# Access Compliance Report

## Public Rights-of-Way

Intersection ID: 5525	Main Street: W_W_T_HARRIS_BV	Cross Street: MCCULLOUGH_DR	Location: W
ADA ID: E771AA368492	Ramp Type: Combination2	Initial Pass/Fail: Fail	Overall Compliance: No
			Severity Score: 13.75

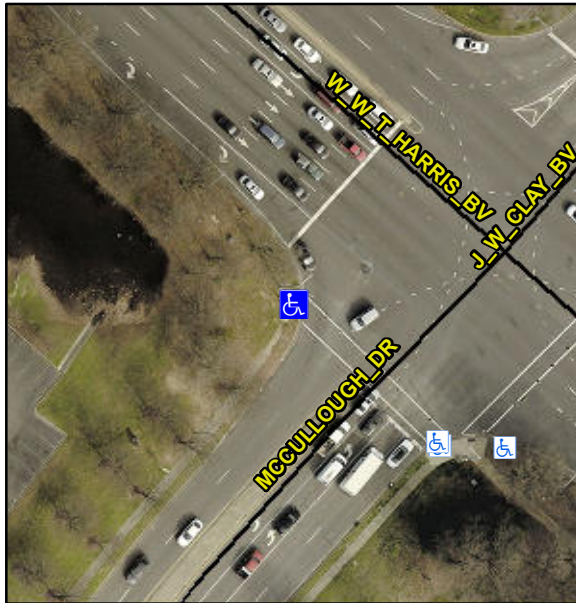
**NO CURB**

**R304.2.2, R304.3.2, R304.5.3**

Compliance	Description	Data	Compliance	Description	Data
N/A	Ramp Length LT (in)	87.5	N/A	Ramp Length RT (in)	N/A
Yes	Ramp Width LT (in)	51.0	N/A	Ramp Width RT (in)	N/A
No	Ramp Slope LT (%)	8.5	N/A	Ramp Slope RT (%)	N/A
No	Ramp XSlope LT (%)	4.4	N/A	Ramp XSlope RT (%)	N/A
N/A	Ramp Length (in)	36.0	No	Ramp Slope (%)	8.5
Yes	Ramp Width (in)	58.0	Yes	Ramp XSlope (%)	0.2
N/A	Flare Type LT	N/A	N/A	Flare Type RT	N/A
N/A	Flare Slope LT (%)	N/A	N/A	Flare Slope RT (%)	N/A
N/A	Flare Traversable LT?	N/A	N/A	Flare Traversable RT?	N/A
N/A	Landing Length (in)	N/A	N/A	DWS Provided?	N/A
N/A	Landing Width (in)	N/A	N/A	DWS Contrast?	N/A
N/A	Landing Slope (%)	N/A	N/A	DWS Length (in)	N/A
N/A	Landing X Slope (%)	N/A	N/A	DWS Full Width?	N/A
N/A	Landing Curb? (Y/N)	N/A	N/A	DWS Offset (in)	N/A
N/A	Shared Landing?	N/A			
N/A	Gutter Ponding?	N/A	N/A	Gutter Slope (%)	N/A
N/A	Gutter Lip Ht (in)	N/A	N/A	Gutter X Slope (%)	N/A
N/A	Painted X Walk1?	No	N/A	Painted X Walk2?	N/A

**Remove & Replace Entire Ramp.**
